General Manager
Liverpool City Council

11 September 2019

I refer to the below email of 5 September 2019 from NSW Planning, Industry & Environment regarding NSW Government concurrence and referral request CNR-1511 for Liverpool City Council's development application DA-262/2019 at 77 BATHURST STREET LIVERPOOL 2170 [Lots 7,8,9,10,11 DP 7451, Lot 4 DP 800326 and SP 38492 (also known as Lot 5 DP 800326)] for 'Demolition of existing building and structures, excavation and remediation of the site, construction of a mixed use development comprising a 4-storey commercial and retail podium including a two level restaurant, two residential towers of 14-storey and 20-storey in height comprising a total of two hundred and sixty four (264) units, above three (3) levels of basement car parking and associated landscaping and services.'. Submissions need to be made to Council by 26 September 2019.

Fire wall constructed for padmount substation at 18 Copeland Street Liverpool. Source: Google Maps Street View.

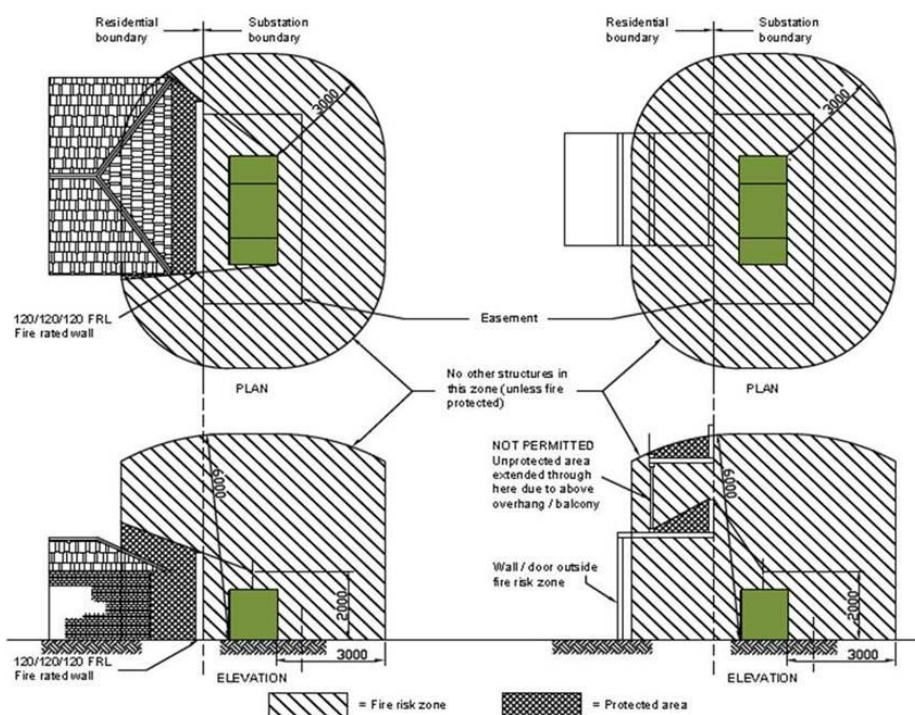
The proposed substation location on a site will require a detailed assessment to consider these issues. For example, to avoid the creation of restrictions on the adjoining site the development shown in the following extract of Google Maps Street View is of a site at 18 Copeland Street Liverpool required the installation of a fire wall next to the padmount substation. Whilst meeting the fire rating requirements etc. from an aesthetics perspective this is not an attractive outcome and possibly an alternative indoor substation may be considered / warranted.

76 Memorial Ave

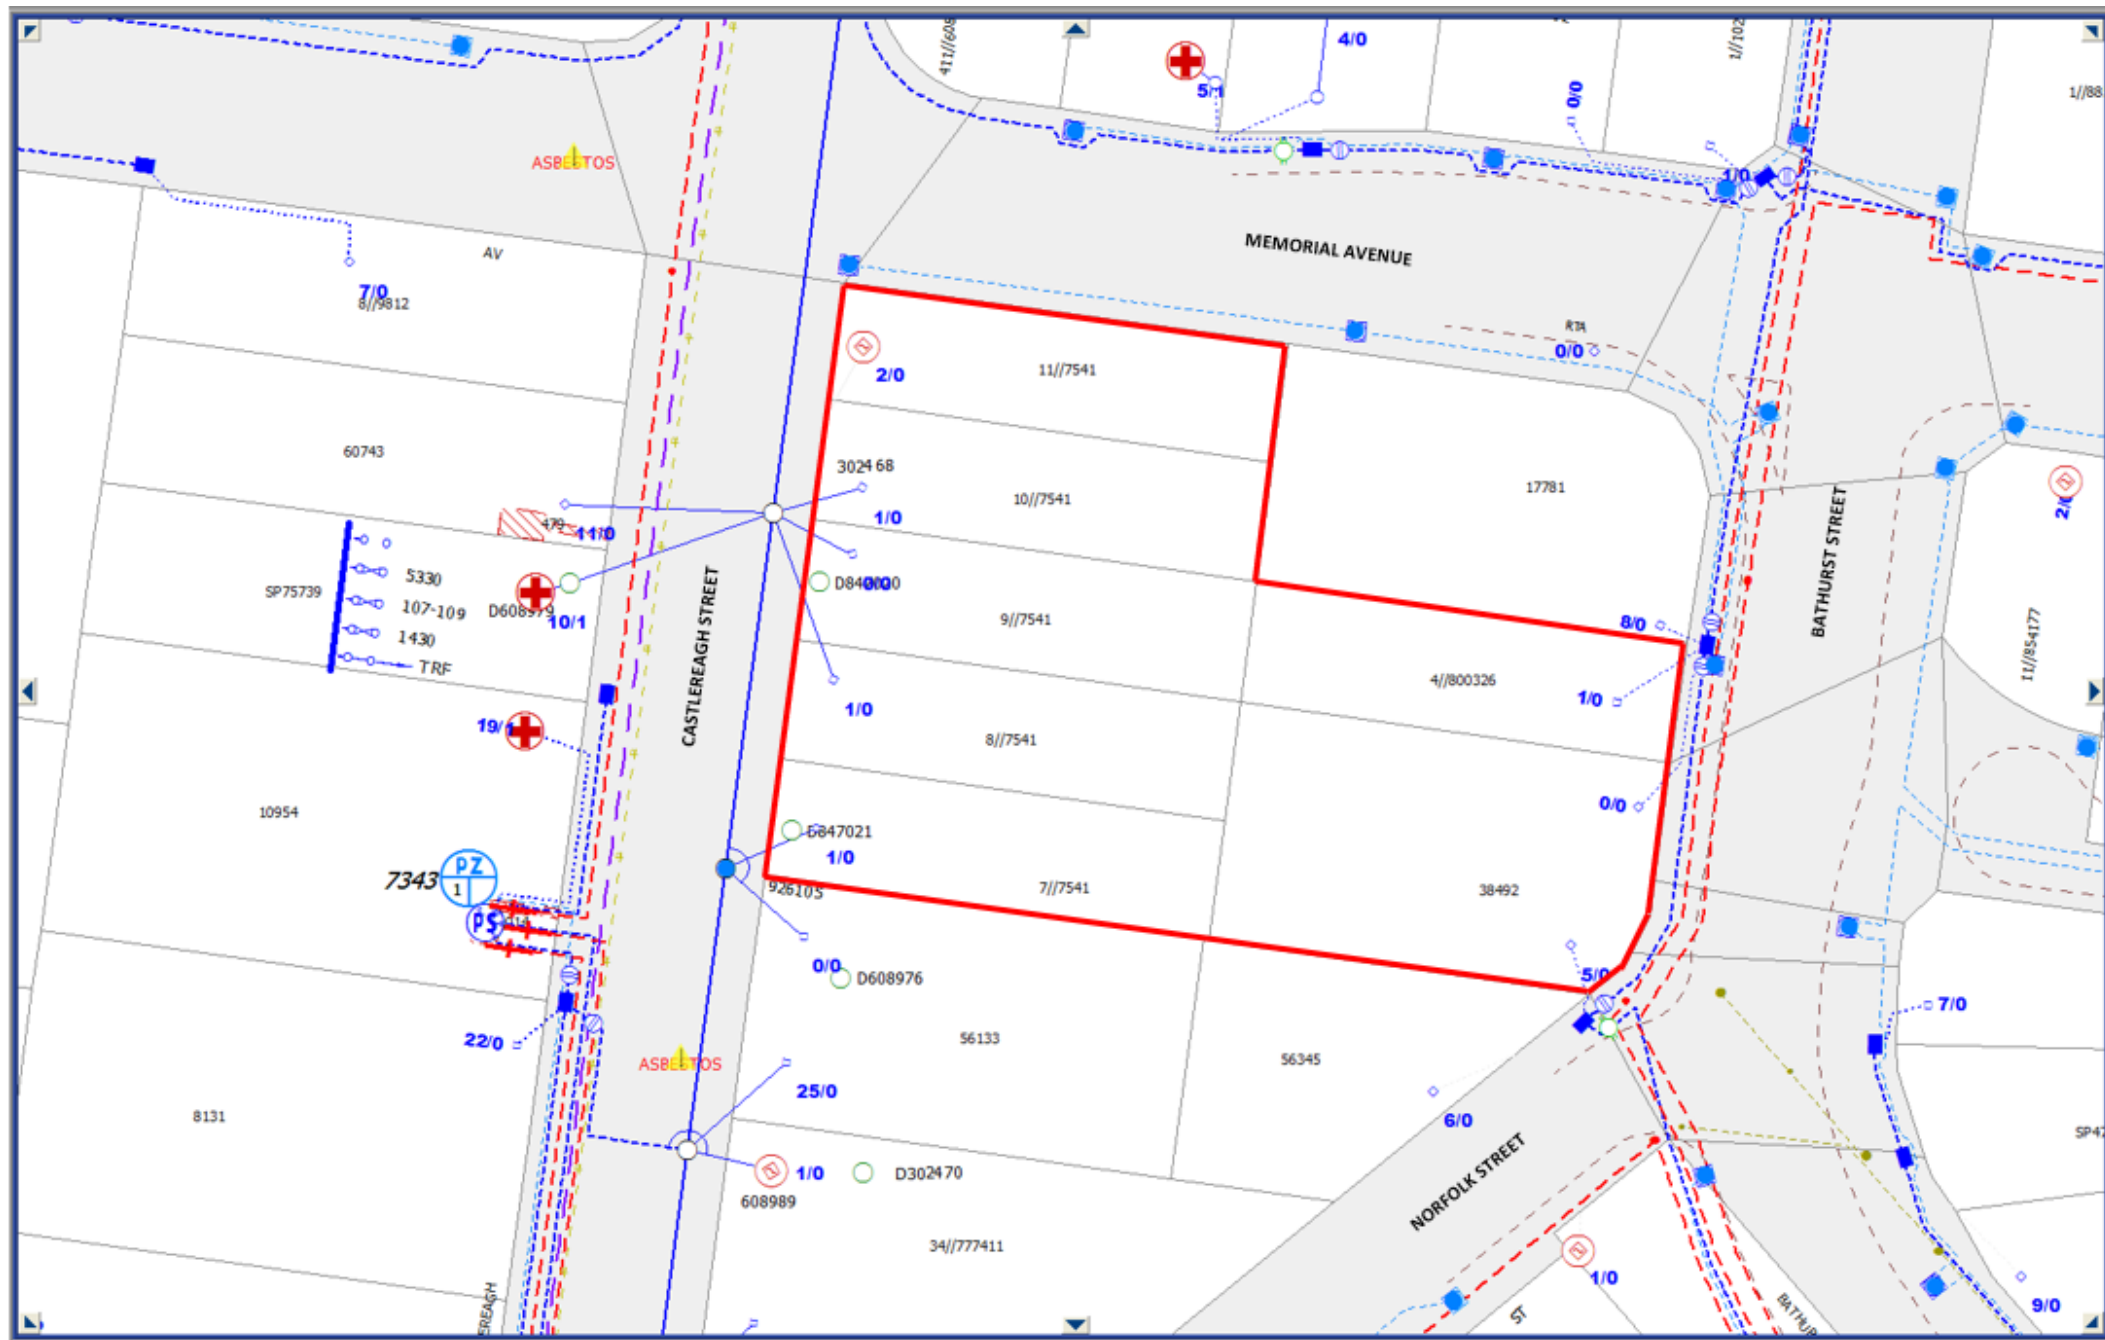
As shown in the below site plan from Endeavour Energy's G/Net master facility model (and extract from Google Maps Street View) there are:

- No easements over the site benefitting Endeavour Energy (active easements are indicated by red hatching).
- Low voltage overhead power lines to the Castlereagh Street road verge / roadway.
- Low voltage and 11,000 volt / 11 kilovolt (kV) high voltage underground cables to the Bathurst Street and Norfolk Street road verges / roadways.
- Low voltage underground cables to the Memorial Avenue road verge / roadway.
